Re: *Comments of the Massachusetts Port Authority on the United States
Environmental Protection Agency (EPA) Proposed Effluent Limitation Guidelines
and New Source Performance Standards for the Airport Deicing Category
Docket No. EPA-HQ-OW-2004-0038*

**Proposed Rulemaking for Effluent Limitation Guidelines and New Source Performance
Standards for the Airport Deicing Category
74 *Fed. Reg.* 44,675 (August 28, 2009)**

Docket No. EPA-HQ-OW-2004-0038

Massachusetts Port Authority

FIGURE 8
UPDATED CDF STUDY-
2020 NORTH PAD

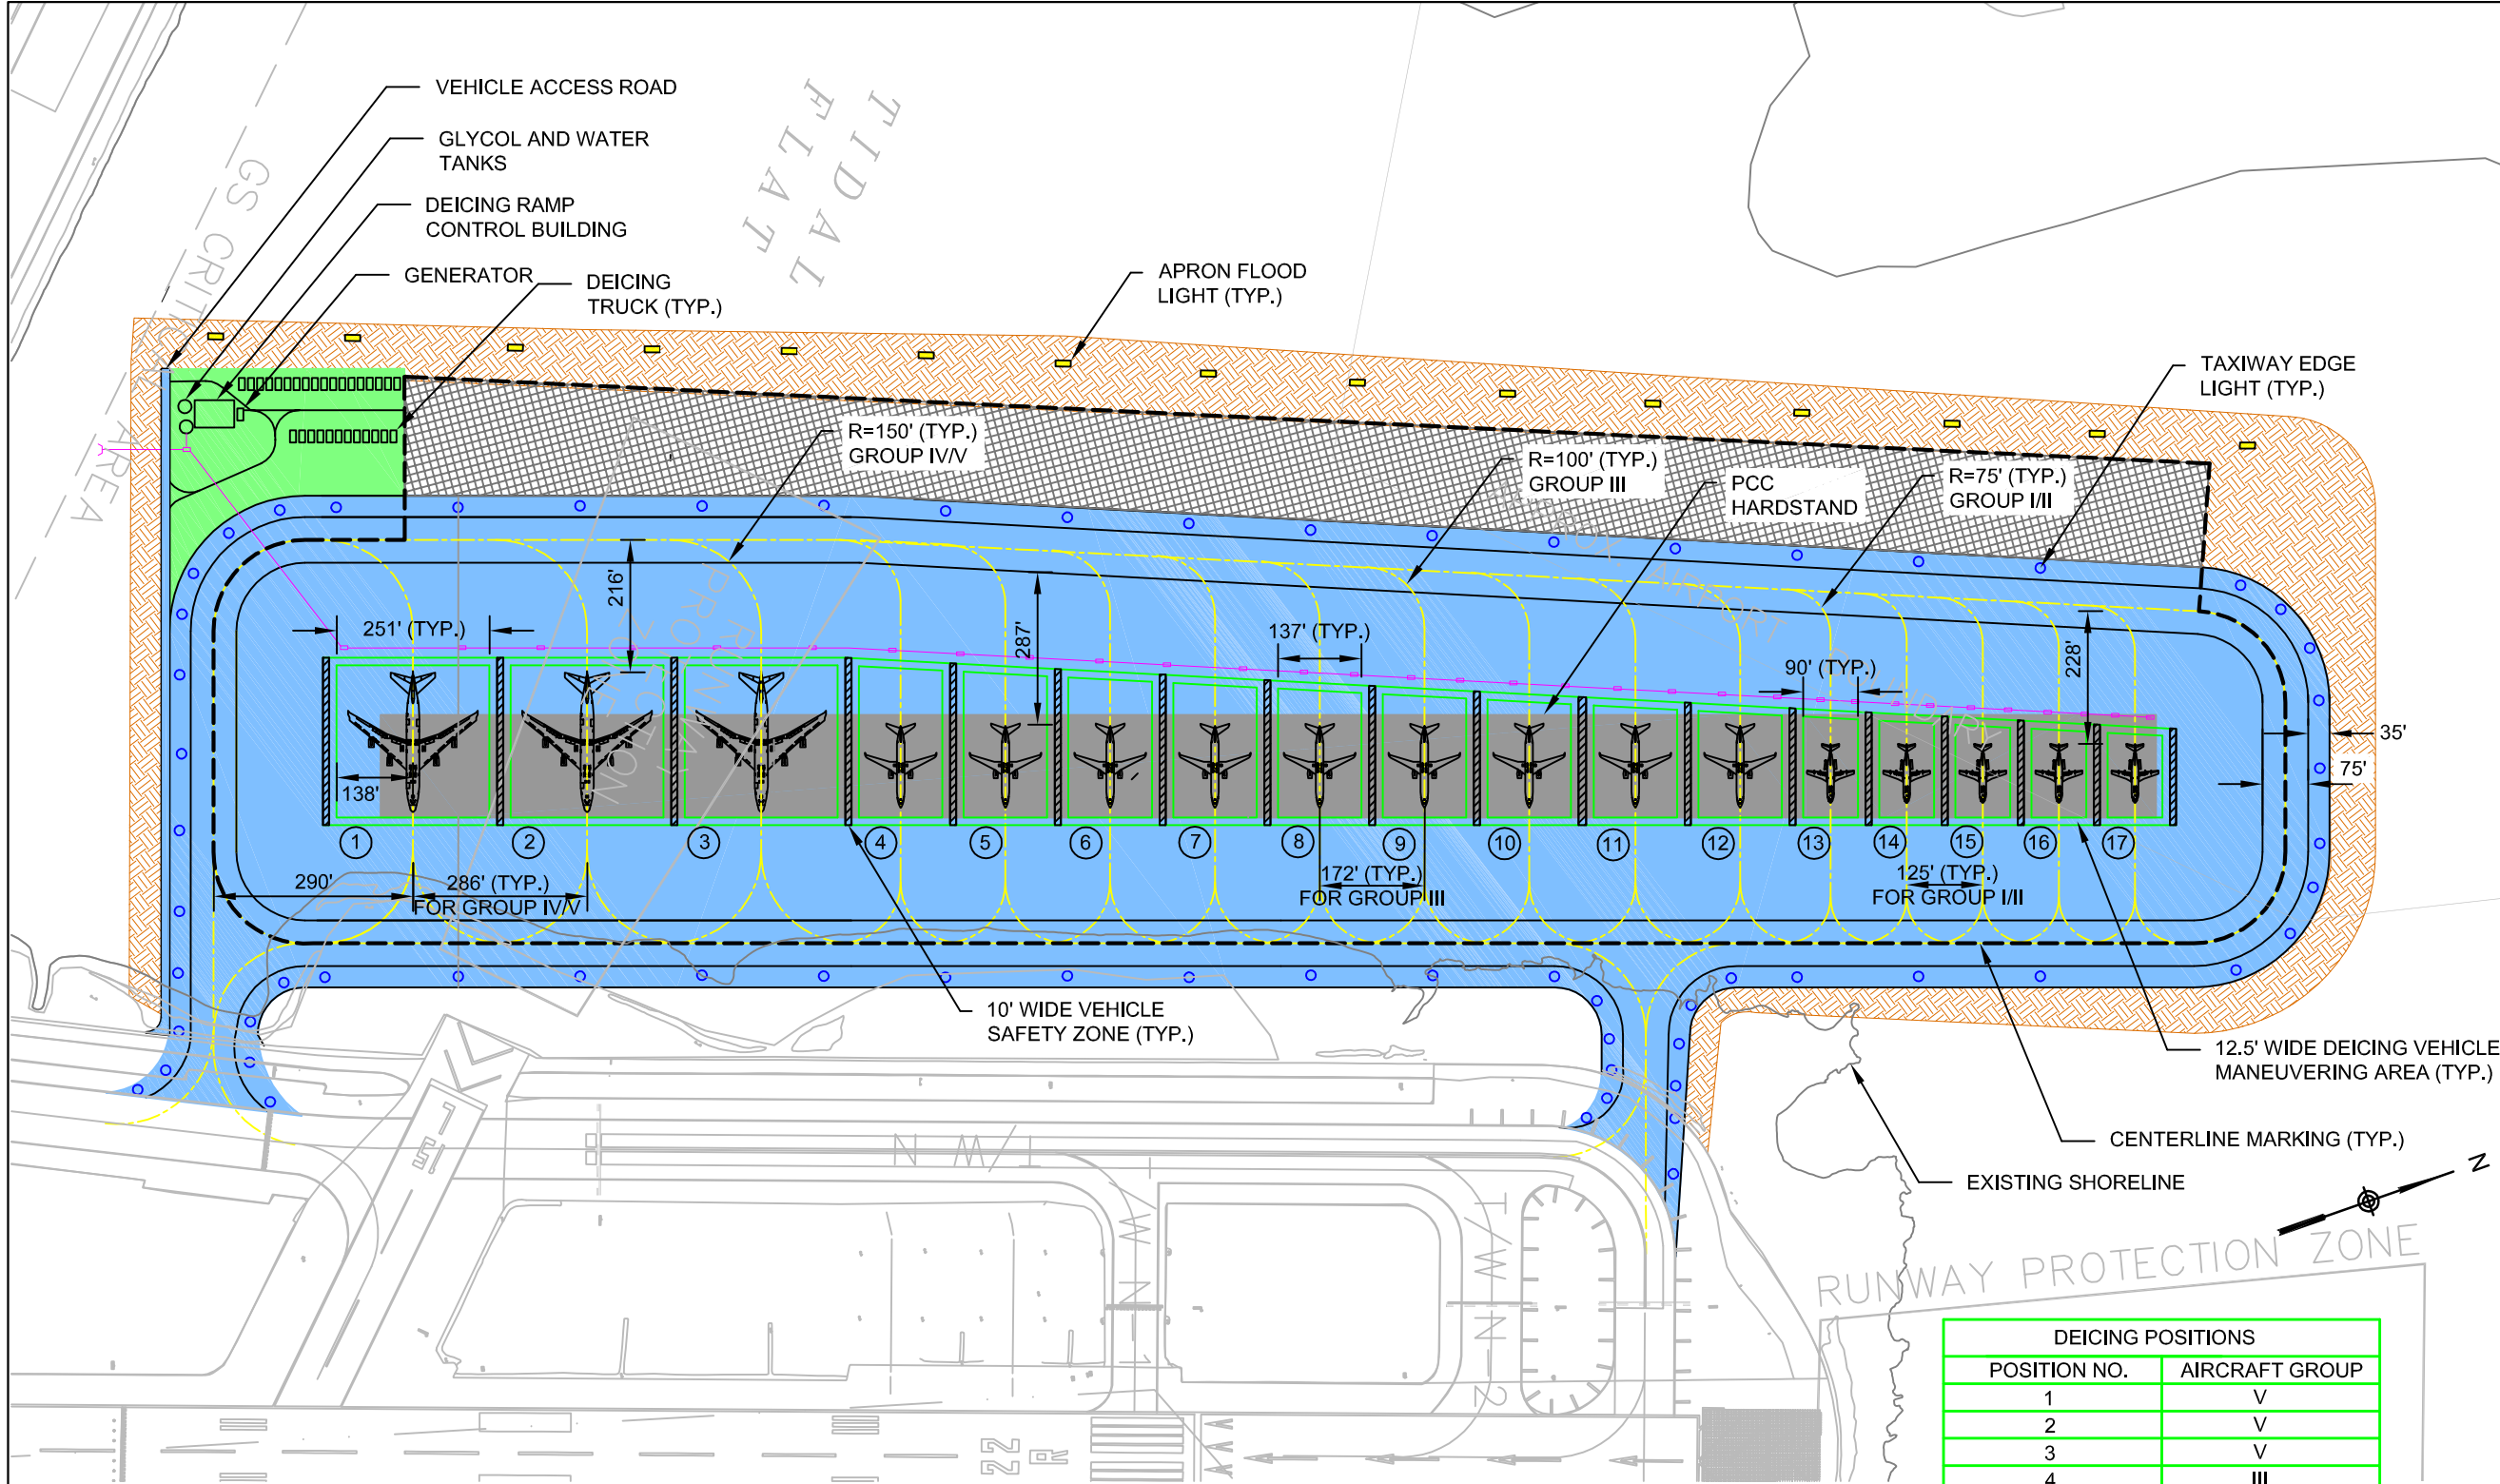
approximately 83 acres, of tidelands would need to be filled or altered.¹⁰³ A theoretical layout for the North Pad is shown in Figure 8.

FIGURE 10
UPDATED CDF STUDY -
2020 JULIET PAD

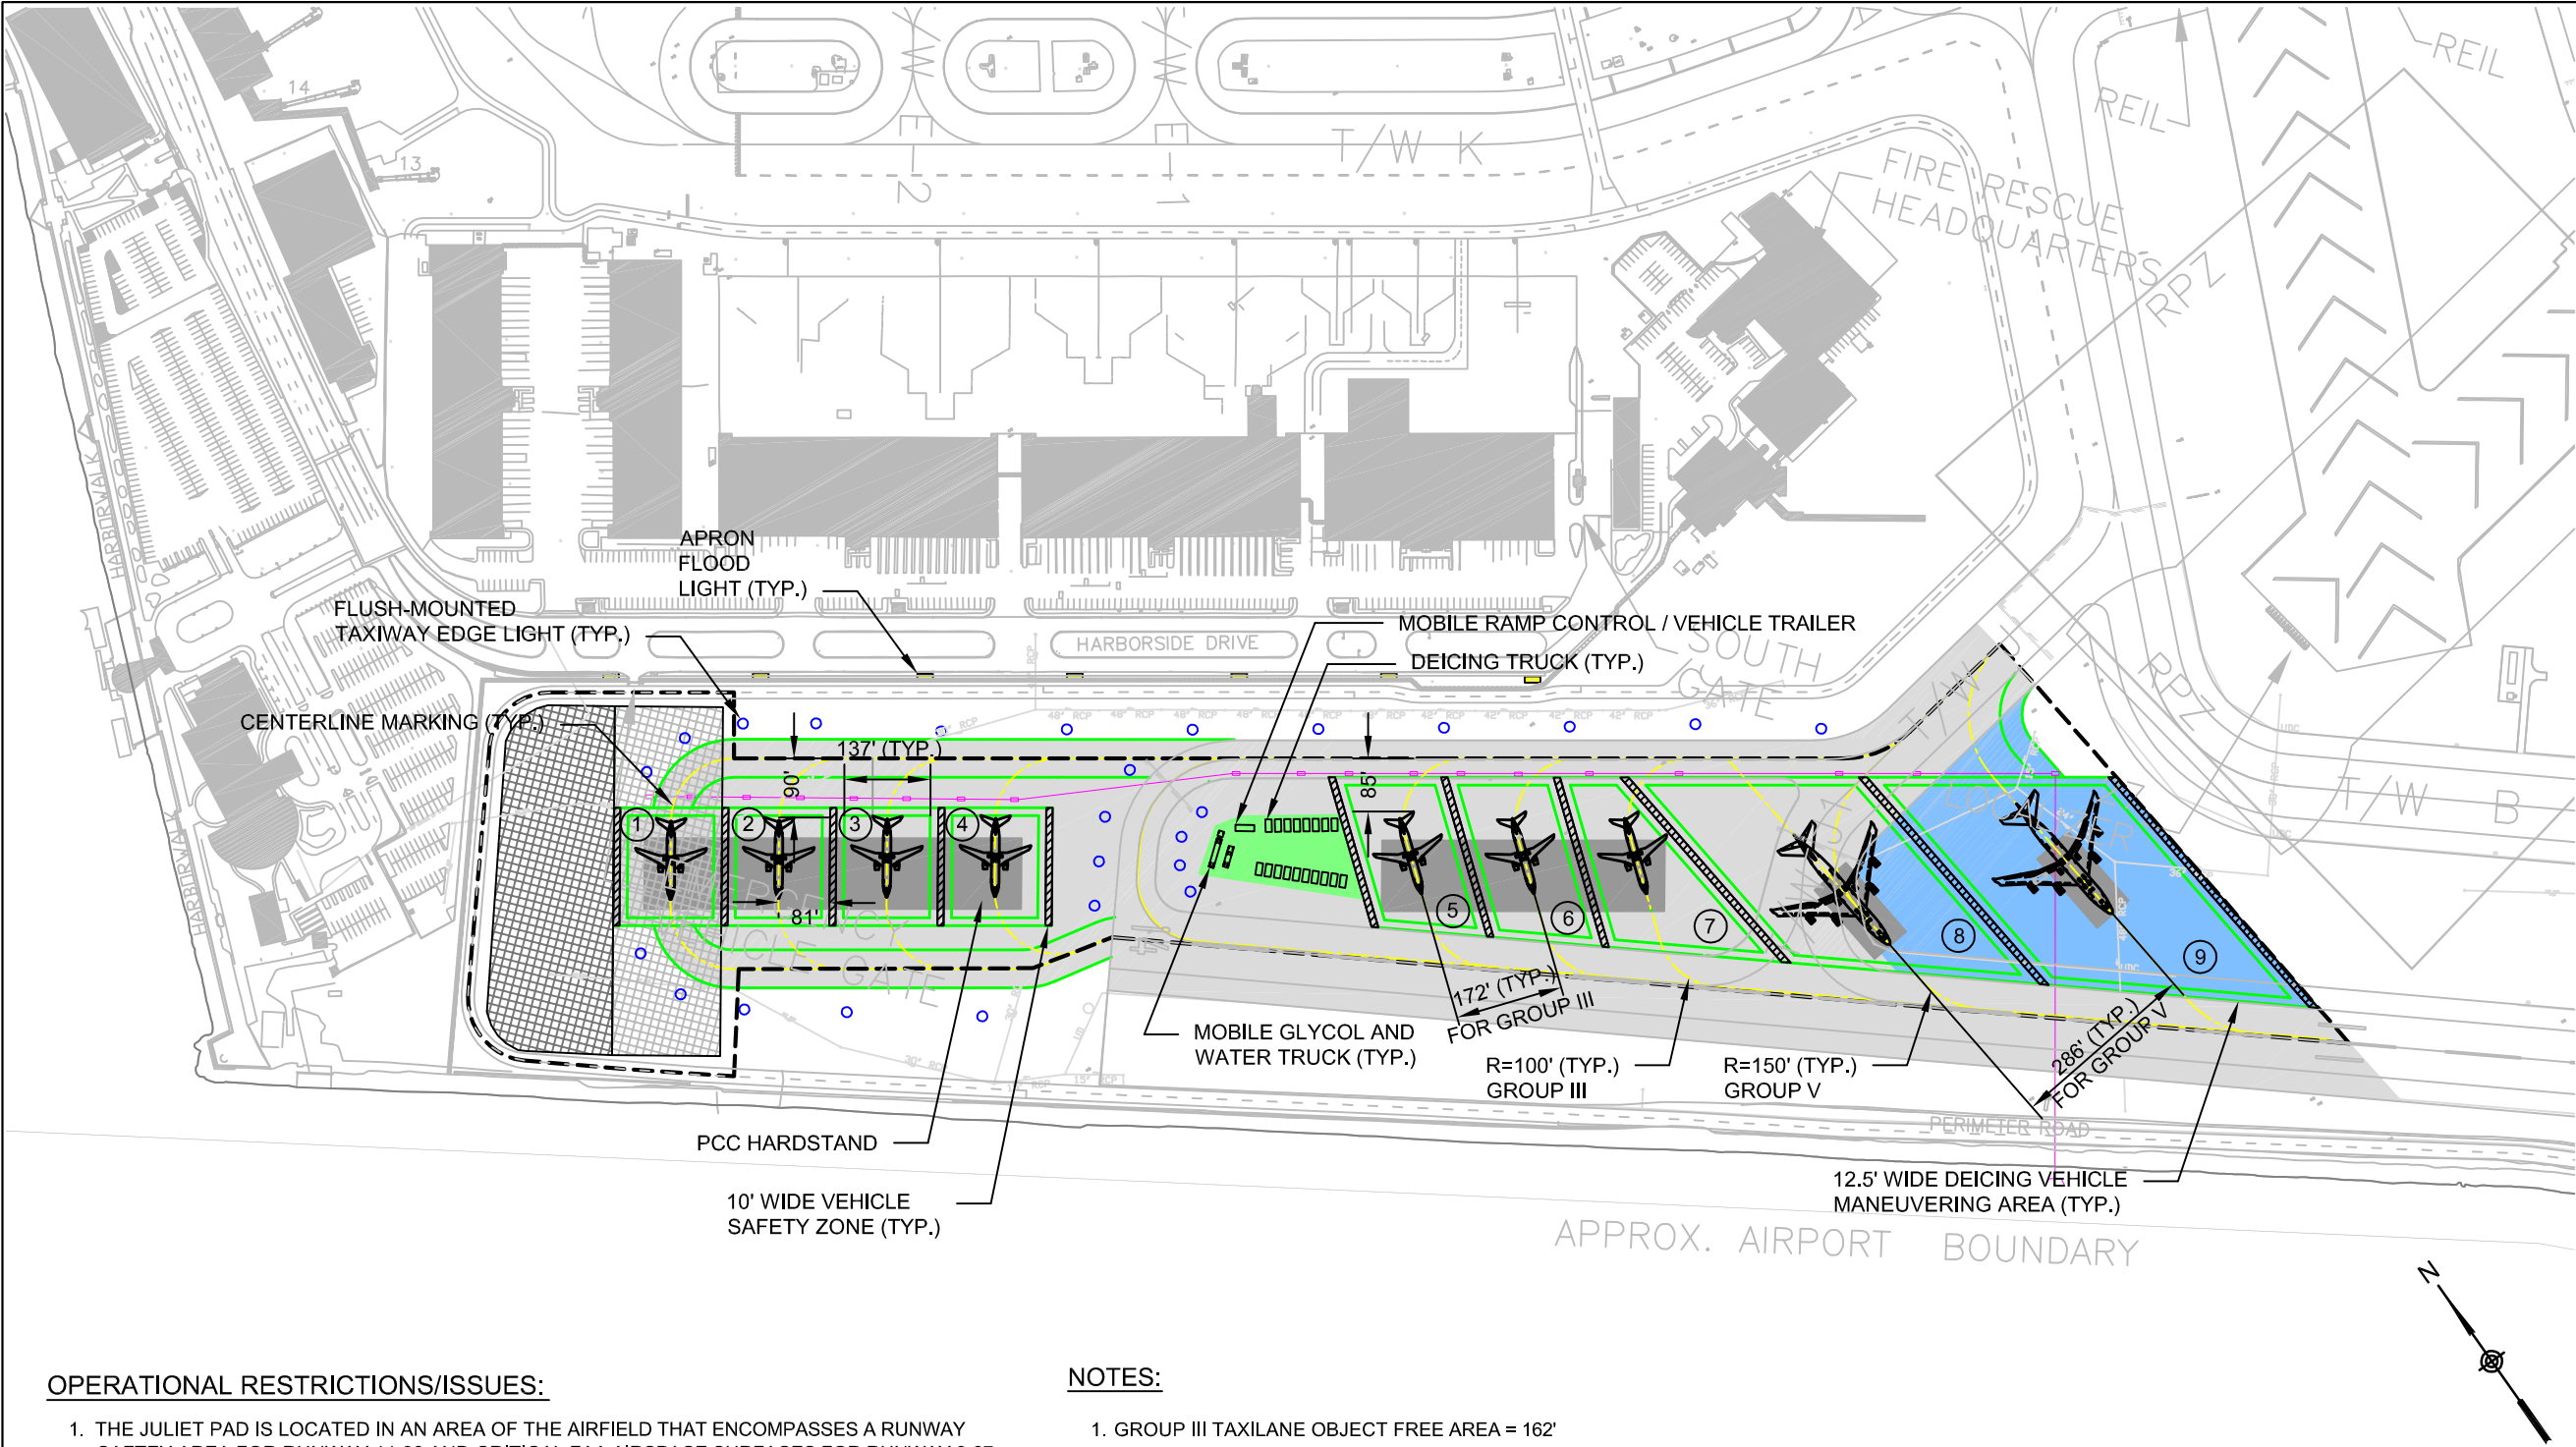
A conceptual layout for the Expanded Juliet Pad is shown in Figure 10. The Expanded Juliet Pad would be laid out in accordance with FAA requirements for deicing facility design. However, due to space constraints, and because the pad would be located in an area of the Boston-Logan airfield that encompasses the Runway 14-32 RSA and critical FAA air space surfaces for Runway 9-27, all support facilities at the Expanded Juliet Pad would have to be portable so that no equipment would remain at the pad when deicing activities have been completed. Temporary support facilities would include a mobile control center, parking areas for deicing trucks, water trucks and mobile deicing fluid storage tankers, and portable lighting.¹⁰⁶

In addition, as shown in Figure 10, one of the nine spots on Juliet Pad would have to be closed when additional snow storage space is needed. This capacity reduction could lead to additional delays. Further, increased taxi distances could increase the possibility that an aircraft would exceed its holdover time before takeoff, forcing it to return to the pad to be de-iced again. In addition, the routes would involve more crossings of runways and/or taxiways and might create two-way traffic on taxiways, all of which have congestion and safety implications.¹³⁶
